Re: Revised Landscape Plans for
Spruce Corner, Acton, Massachusetts
PLACES Proposal No. 616

Town of Acton
Planning Department

LANDSCAPE PLAN
 ACTON, MASSACHUSETTS
 PREPARED FOR

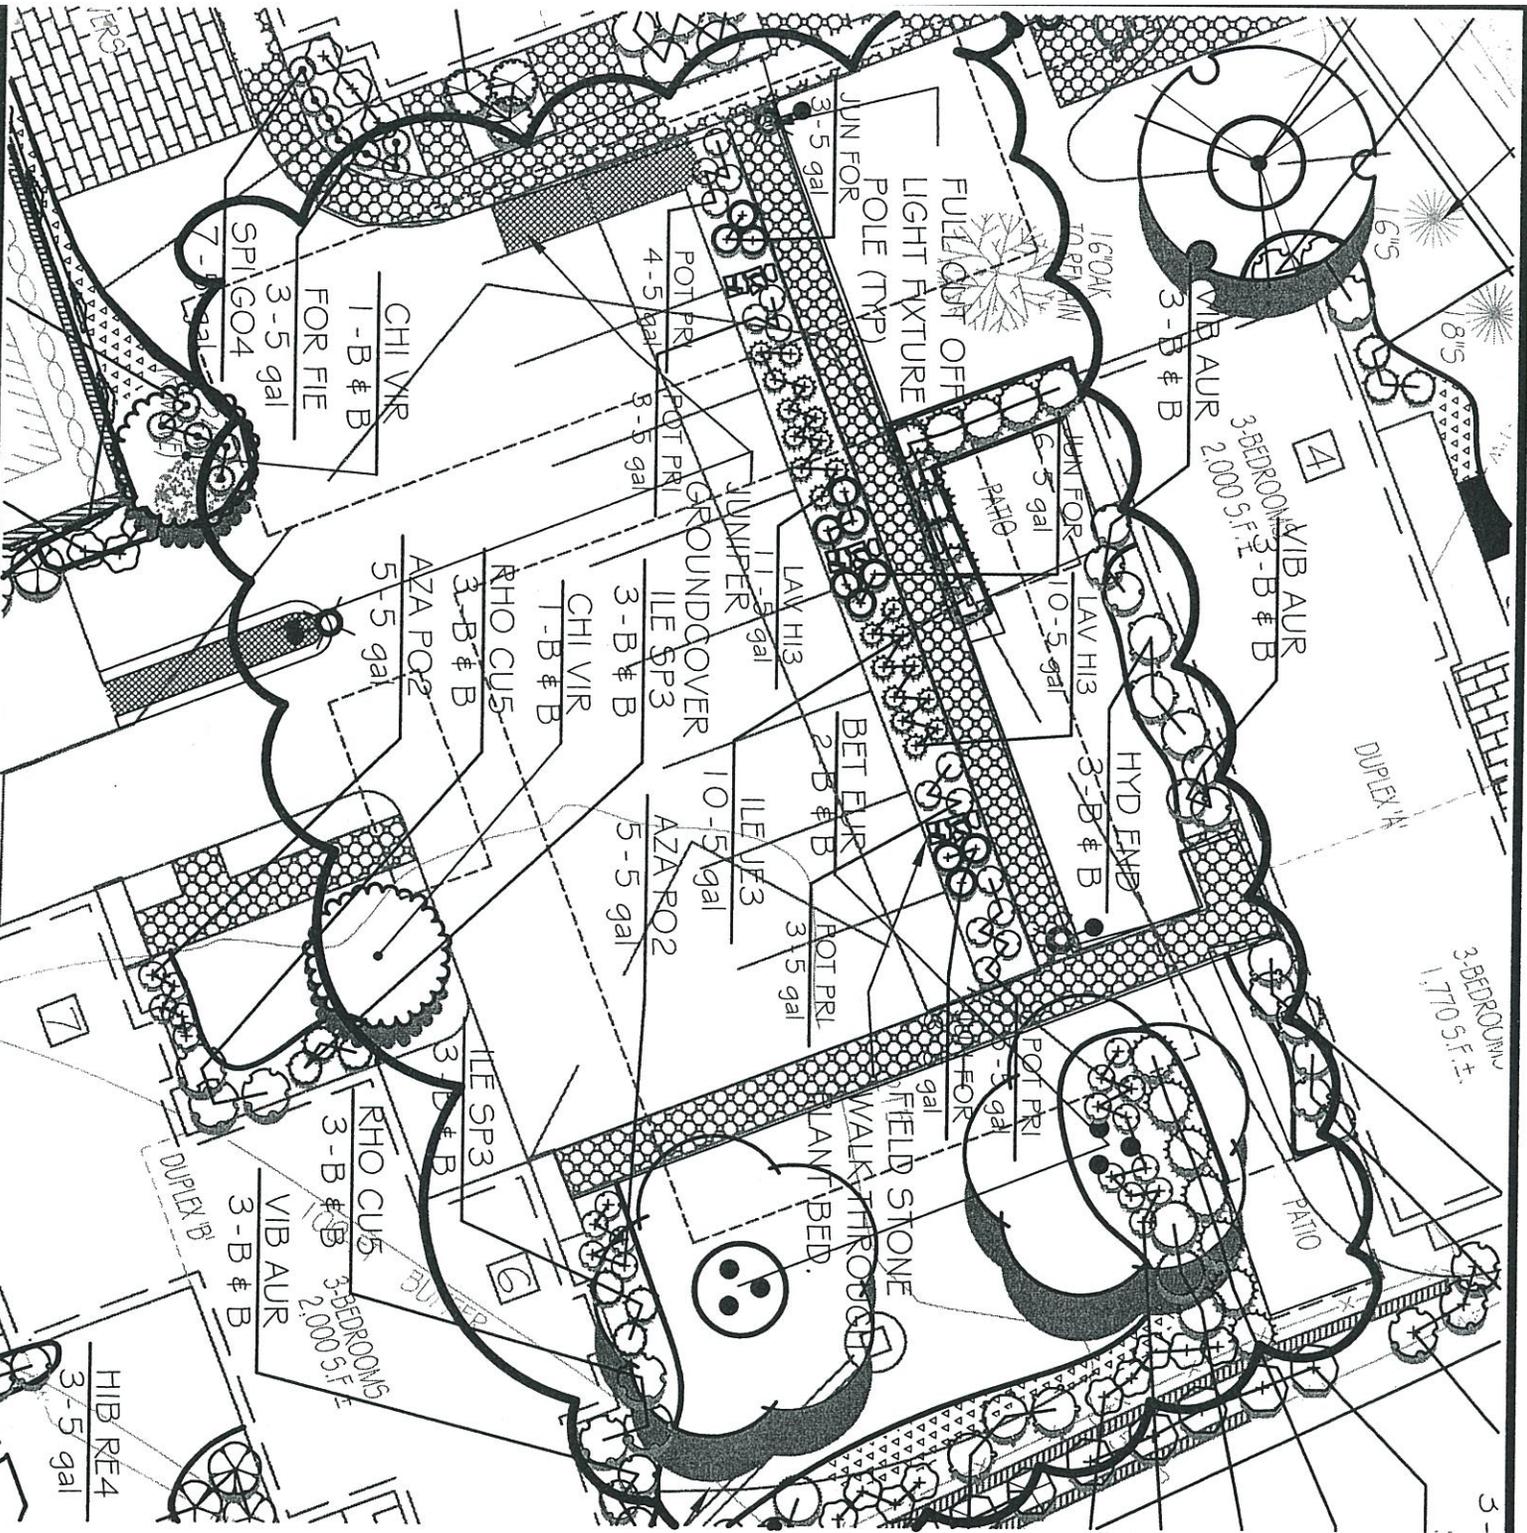
2. We have provided an 8-1/2 x 11" Landscape Calculation sheet that depicts the "area" identified by Zoning § 6.9.4.7.b, for both paved area and areas considered part of the parking area. The proposed landscaping around the "open space" and as part of the "wall-scape" act to meet buffer to the east, as does the buffer plantings adjacent to foundations and at the entrance to the site. The proposed buildings act to buffer adjacent properties to the north and west of the development. A dense, landscaped screen of arborvitae, 6'tall vine planted fence and other seasonal plantings screen the auto body shop located to the south-west of the site. The open space to the west is included in our calculation of buffer planting and exceeds the 20% minimum, non – impervious buffer criteria.

Parking Area

Calculations:

(Per Zoning: G.9.4.7)

Total Area = 8,843 sf

(clouded)

Paved Areas = 4,500±sf

Parking Lot = 3,392sf

Walks = 812sf

Patios = 250 sf

Required: 1 tree per 2,000 sf of pavement.

Trees provided:

- Exist 16" Oak
- 2 - Birch clumps
- 2 - Fringe Trees
- Total 5 trees

Per Standard: 5 shade trees quality for 10,000 sf. of paved area.
